AI#2 Appendix C

Peat Technical Note

Response to the SEPA Objection (17 April 2020)

3.12 Turbine 32

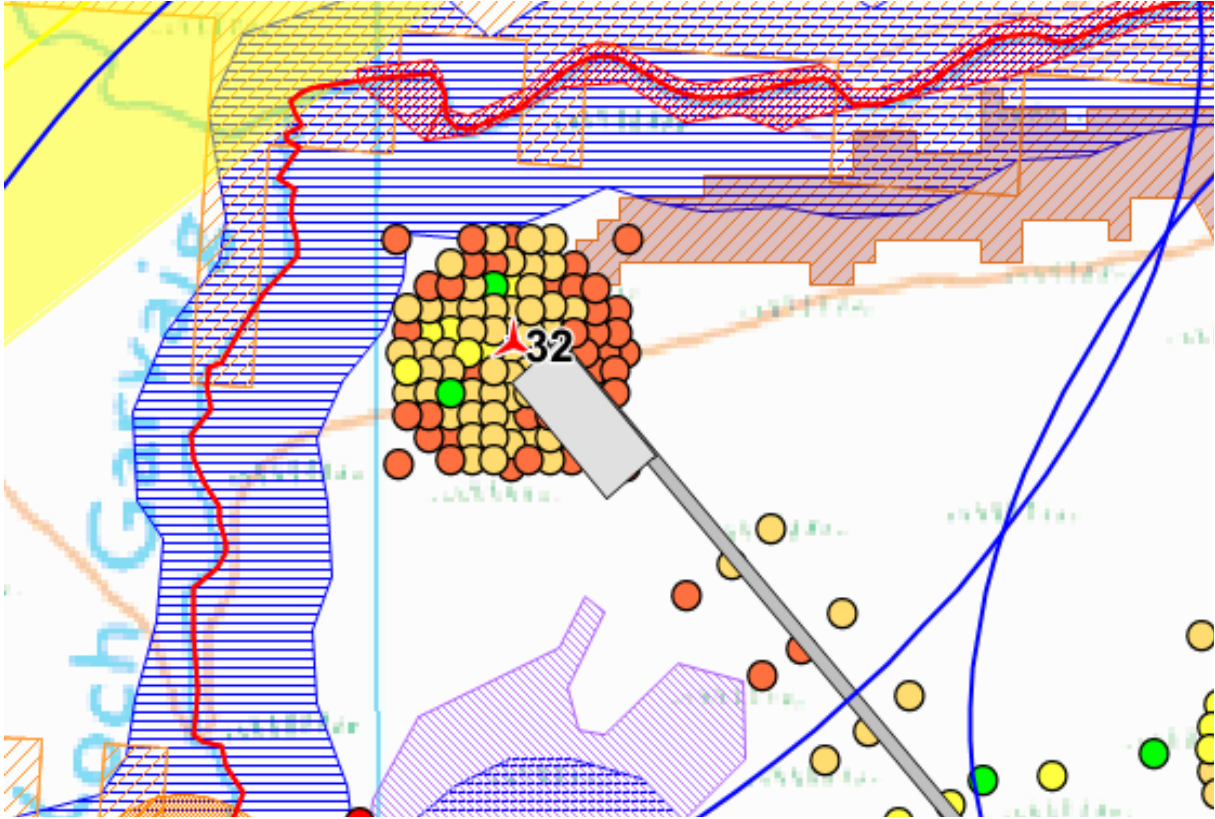
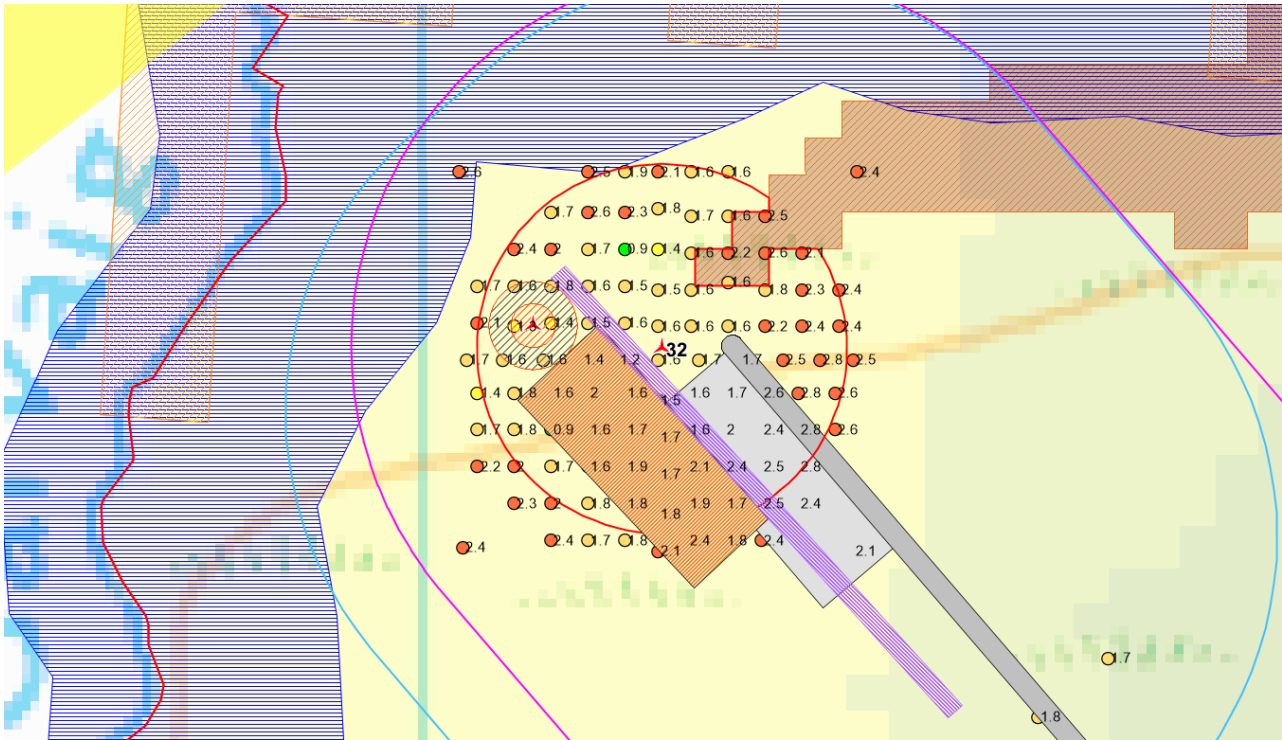
- 3.12.2 SEPA identified that T32 is located within peat that is 2-3m deep and should be moved into shallower peat directly south-east along the access track, closer to where the intersection with the main track occurs, where probing depths indicate 0.5-2m (light and dark green areas). Alternatively, the crane pad could be moved onto the shallower peat on the other side of the turbine.

- 3.12.3 This move was reviewed and T32 is currently located in peat below 2m, therefore it is unlikely to be of benefit to move this turbine and moving south would further impact on the wake separation with other turbines. However, there is scope to move the turbine to the west and move the crane pad slightly west to bring the pad into areas of shallower peat.

- 3.12.4 **Figure 3.11b** shows the proposed slightly amended location of T32. This would move T32 from 1.6m deep peat to 1.3m deep peat, and would move the crane hard stand into slightly shallower peat.
- 3.12.5 The change would also result in a small change to the track alignment.
- 3.12.6 Before reaching this conclusion, a number of other locations were identified, and dismissed as they would result in no additional saving of peat.
- 3.12.7 In relocating the turbine here, a saving of 684m³ of peat (approximately 20%) could be achieved when compared to the as submitted scheme.
